**M54 to M6 Link Road  
TR010054**

**8.19 Applicant Responses to Examining  
Authority's Second Written Questions,  
Representations Made at Deadlines 2, 3  
and 3a and Matters Raised During  
Hearings in December 2020**

**Applicant Response to ExA's Second Written Questions, Representations  
Made at Deadlines 2, 3 and 3a and Responses to Issues Raised at  
Hearings in December 2020**

| <b>Application Document Reference</b>         | TR010054/APP/8.19                                      |

## **Appendix 2.9.2 Copy of Figure 1 of Appendix 10.1 of the ES [APP-193/6.3] for ease of reference**

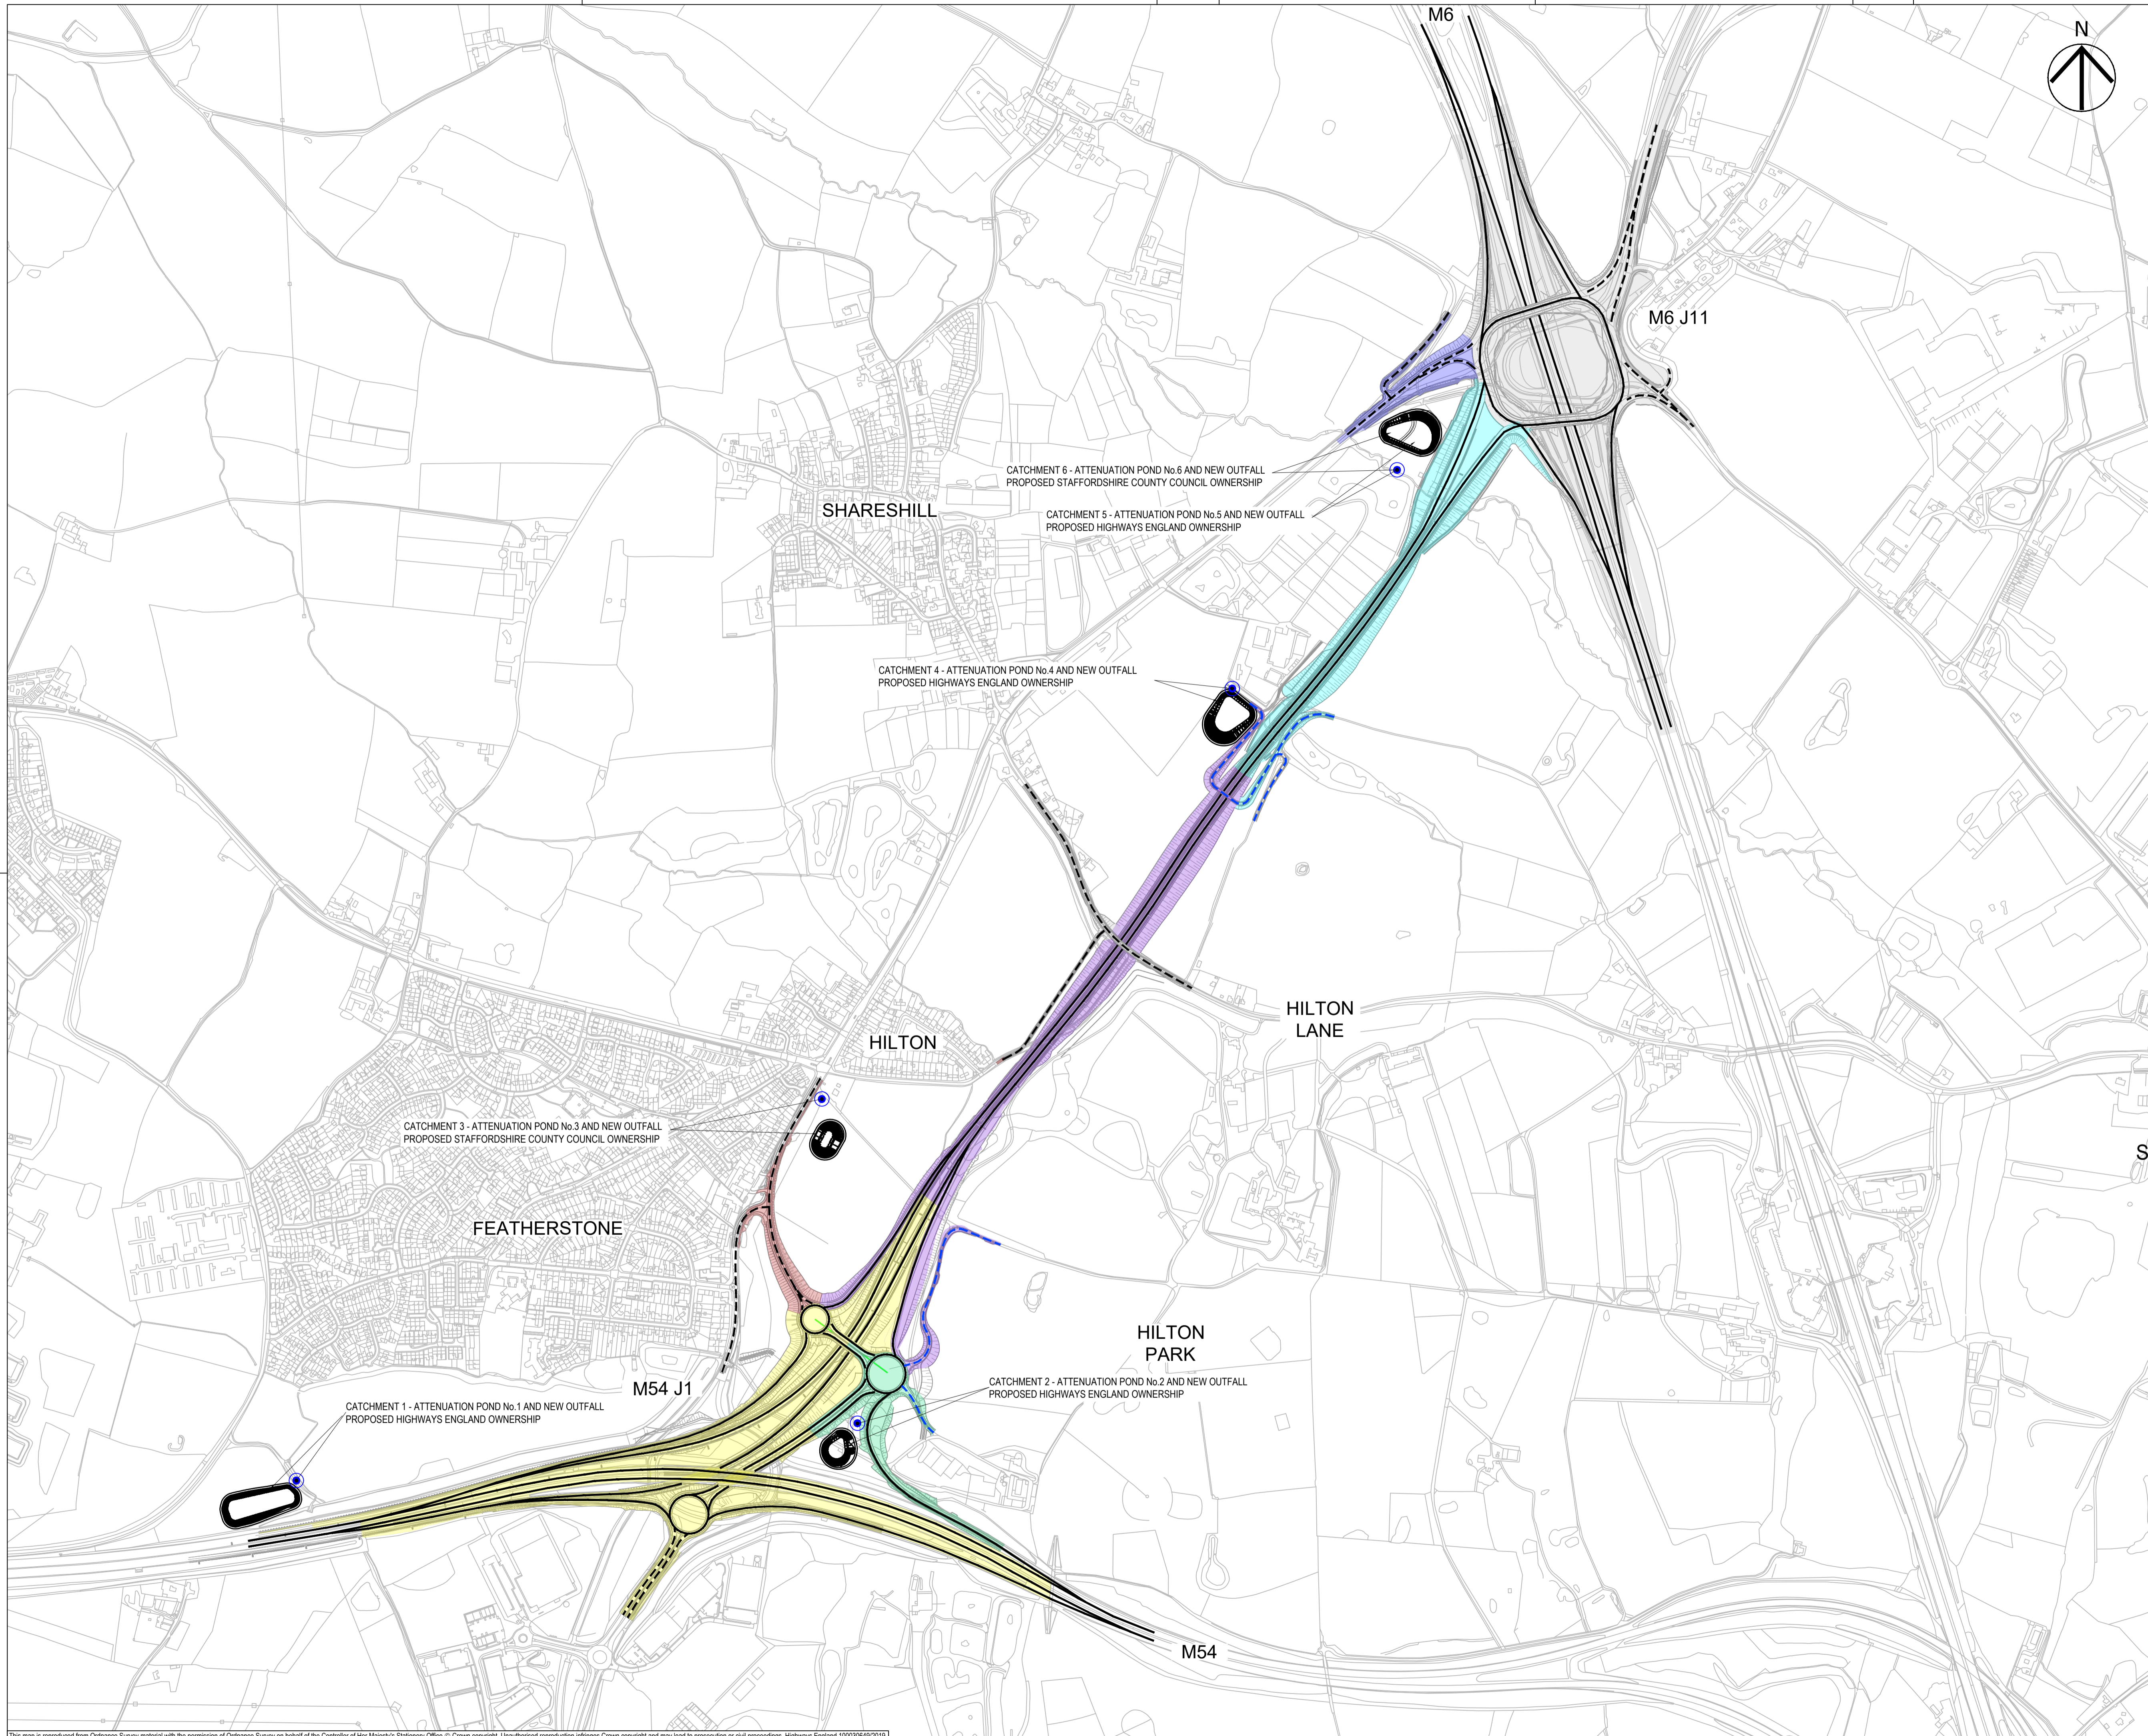
| 2.8   |               | Noise and Vibration   |  |
|-------|---------------|---|--|
| 2.9.2 | The Applicant | <p><b>Use of Soils and Gravel on site</b></p> <p>SCC in its response to ExQ1.12.1 [REP1-006] indicates that "there should be an assessment on whether 1) sand and gravel that would be sterilised could be used within the scheme as construction aggregate (not just as fill material); and 2) the extent of sterilised sand and gravel that could be otherwise extracted from Hilton Park Quarry". Could the Applicant please undertake these analyses.</p> | <p>A response to SCC was provided in the Applicant Responses to Written Question Responses from Interested Parties WQ1.12.1 [REP2-009] as follows:</p> <p>1) Consideration will be given to the use of site won materials during the construction phase, where appropriate, including bedrock sand. This will be considered in greater detail during the detailed design stage.</p> <p>2) As set out in Appendix 10.1 of the ES [APP-193/6.3] Hilton Park has been non-operational for many years, but there remain permitted reserves. Planning permission for bedrock sand and gravel extraction was originally granted in 1955 and expires in 2042. Appendix 10.1 concludes that "<i>it has been demonstrated that the Scheme would not unduly restrict the mineral operations at the Hilton Park site should operations recommence at some point in the future. The requirements of MLP Policy 3 relating to safeguarding mineral infrastructure sites (specifically Policy 3.2 (b) and Policy 3.5 (a)) have been met.</i>" Therefore, the Scheme would not sterilise sand and gravel within Hilton Park Quarry.</p> <p>Figure 1 of Appendix 10.1 [APP-193/6.3] of the ES, which illustrates the location of the Mineral Safeguard Area and site of Hilton Park Quarry, is provided as Appendix 2.9.2 to this report for information.</p>  |
